1 Technical Note – Environmental Health Consultation Response

- 1.1 Arun District Council are currently determining a planning application (A/39/21?DOC) seeking the discharge of Condition 9 of the outline planning permission granted for a new residential development on Land South of Water Lane, Angmering (outline permission ref. A/99/17/OUT).

- 1.2 The application to discharge the condition was accompanied by a “*Sound Insulation Assessment*” prepared by Mayer Brown Limited.
- 1.3 The report has been reviewed by the District Council’s Environmental Health Team who have made a number of comments (as set out in the EH Team’s email response to the planning case officer on 16th April 2021).

Figure 1: Facades with $L_{Amax,fast} > 69$ dB

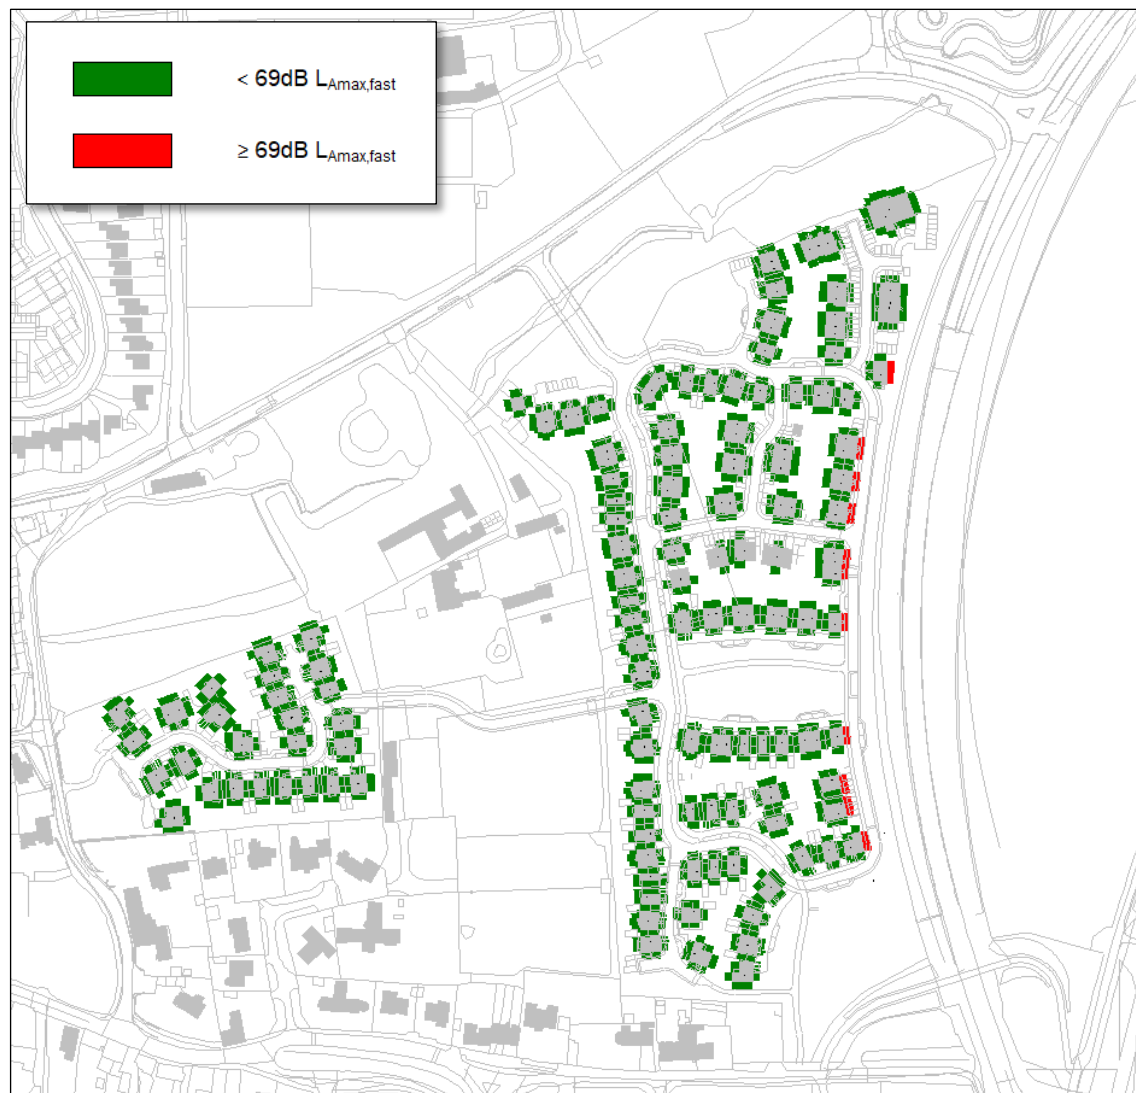
“This level of $L_{Amax,f}$ indicates a medium risk of potential for sleep disturbance and therefore the need for increased noise mitigation in the form of mechanical forced air ventilation to those houses/flats adjacent to the A280.”

- 1.16 Notwithstanding the above, the EH Team’s response indicates that they expect alternative mitigation to be included for the houses/flats adjacent to the A280, i.e. that these should be provided with “mechanical forced ventilation”. Based on details approved for other recent development in the locality¹, it is understood that the required ventilation should be provided to the standard of “System 3” or “System 4” of Approved Document F of the Building Regulations. For the avoidance of doubt:

- 1.28 As noted earlier, the WHO, ProPG and AVOG guidance routinely referenced imply that a value of 60dB $L_{Amax,fast}$ represents LOAEL and 78dB $L_{Amax,fast}$ represented SOAEL, so the Protection Value determined from the Griefahn is approximately mid-way between LOAEL and SOAEL. A value of 69-70dB $L_{Amax,fast}$ therefore appears to represent a reasonable basis for reviewing the potential need for mechanical ventilation suggested by the Council's EH Team.
- 1.29 In order to identify dwellings, a more detailed assessment of $L_{Amax,fast}$ noise levels across the proposed development by creating a computational three dimensional noise model. The building evaluation software has then been used to identify building facades exceeding 69dB $L_{Amax,fast}$. The output of the model is presented below:
